Statement

Product Name: LTE Cat 1 bis Module

Model Number: EG915K-LA

Hardware Version: R1.0, R1.1

- **PCB Layout changes**

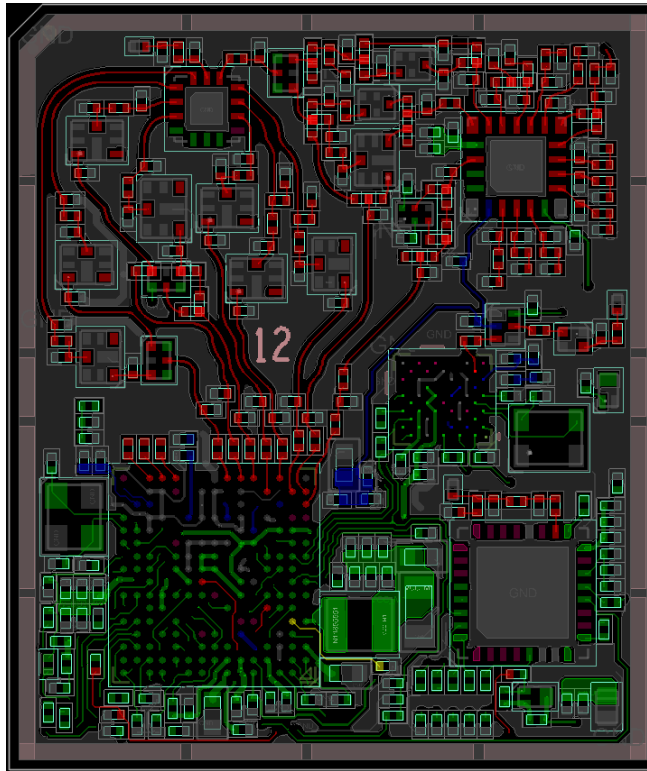
EG915K-LA has three versions as following. All versions share the same HW design, the difference is as following:

Module	Hardware	Chipset	Frequency
EG915K-LA(LA)	R1.0	ASR1602S	LTE: B2/3/4/5/7/8/28/66 BLUETOOTH
EG915K-LA(LG)	R1.1	ASR1602S	LTE: B2/3/4/5/7/8/28/66 GNSS
EG915K-LA(LC)	R1.1	ASR1602S	LTE: B2/3/4/5/7/8/28/66

Designator	EG915K-LA(LA) (Part Description)	EG915K-LA(LG) (Part Description)	EG915K-LA(LC) (Part Description)
U0701	IC BT ASR5801 32-QFN32 4x4mm H0.9mm RO	None	None
Q0701	AUD PMOS VDS=-30V -0.57A Vth= +/-10V DFN1006-3L RO	None	None
D0701	TVS Bi Vrwm=5.0V 0.15pF CH0201 RO	None	None
U0803	None	IC BB GNSS ASR5311 49-BGA 0.35pitch 3x2.7525mm H0.93mm RO	None
D0801	None	TVS Bi Vrwm=5.0V 0.15pF CH0201 RO	None
U0801	None	IC RF LNA GNSS L1/L5 PINS6 1.05x0.65mm H0.4mm RO	None
U0802	None	IC RF RX filter GPS/GLONASS/BEIDOU Unbalance 15dBm PINS4 0.9x0.7mm H0.55mm RO	None
Y0802	None	CRY TCXO 26MHz +/-0.5ppm 1.8V 2.0x1.6mm H0.8mm RO	None

The change will not impact RF performance for the other frequency bands.
